ADDENDUM NO. 3

City of Suffolk
IFB #22124-AG
June 28, 2022

SUFFOLK ZONE 'C' OPERATIONS FACILITY – PHASE 1 EARLY SITE PACKAGE

RE: **ADDENDUM No. 3**
FOR THE PROJECT BIDDING DOCUMENTS

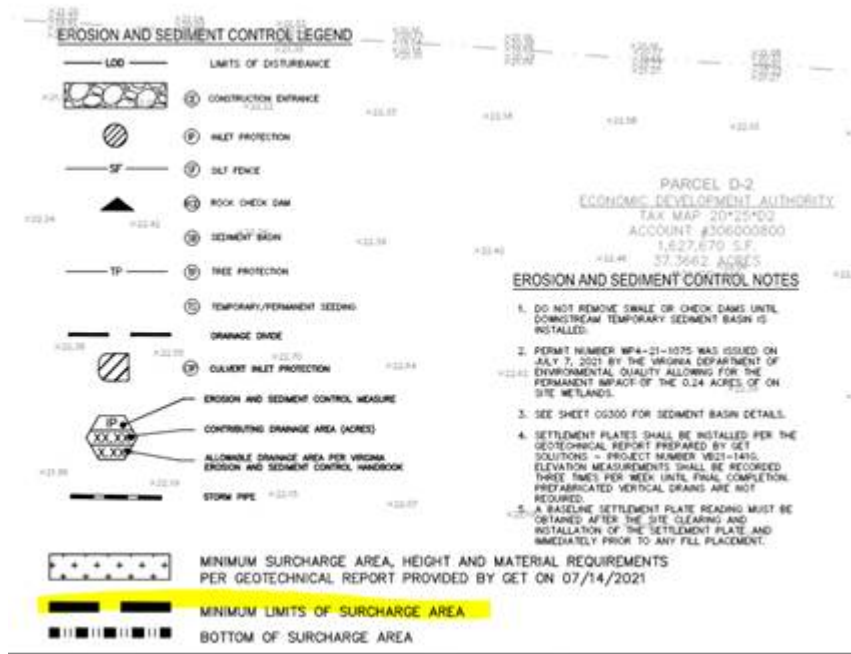
QUESTION #3: Refer to sheet CG102. Where does power come from to feed the electrical panel for the aeration compressor.

RESPONSE #3: **DELETE** all references to the aeration compressor cabinet and pond aerator. This is not within the scope of work for this phase.
